The Heath & Hampstead Society

To London Borough of Camden, Tree Preservation Team

Planning Ref: 2020/5783/T
Address: Camden Arts Centre
Case Officer: Tree Allocation Team
Date: 5th February 2021

From: nw3weather.co.uk

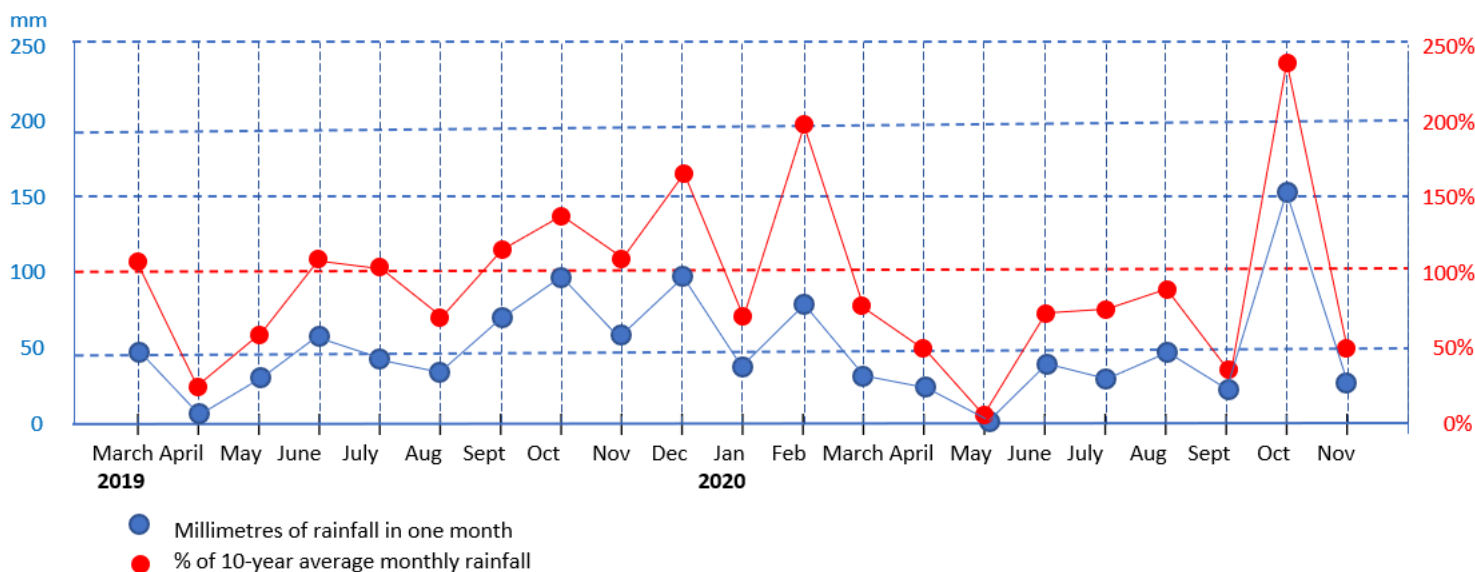
This degree of movement might be expected merely for clay expansion and contraction. Since there is clearly more movement than this occurring in the buildings and walls, it brings the datum into question, a pillar perhaps also likely to be affected by silt erosion, hill movement or trees – if it were indeed possible

that these trees, shrubs and grasses really were capable of what they are being accused of. This very unsatisfactory movement 'monitoring' fails to give data for the datum.

The table also fails to reflect in any way the rainfall over this period, whether looking at the actual amount or the percentage of the 30-year average for that month. It fails to show any effect of leaf fall and leaf burst if the trees were to be taken seriously as significant causes. In fact quite the opposite. If the downward movement of monitor points are lowest in November 2019, this is when leaf fall has already occurred and when rainfall is slightly above average. Through this period it is true that the rainfall of most months tends to be below average, but it is not remarkable apart from a very dry April 2019, though this is followed by slightly above average rainfall in June and July.

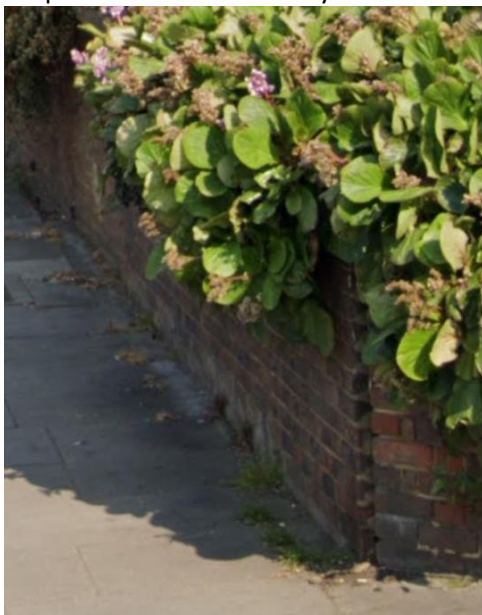
Since the previous Notice of Intent the cracks have continued to widen and increase. The retaining wall along the Finchley Road is also moving a little further. I'm afraid I cannot see how a cherry and a rowan tree of no great size, some pampas grass and buddleia is supposed, from quite a distance away uphill, to be able to move this hillside down towards the Finchley Road

September 2017 Cracking at joints each end of the diagonal retaining wall - being pushed downhill

November 2019 Finchley Road wall slightly moved out/over; Arkwright corner joint further open; Old crack reopened near the Finchley Road end of the diagonal wall:

January 2021 Crack in the joint at the Arkwright Road end of the diagonal wall has opened further

Extended crack, far right front window; New subsidence, main part diagonal wall – silt erosion?
(N.B. the dampness here is snow melt)
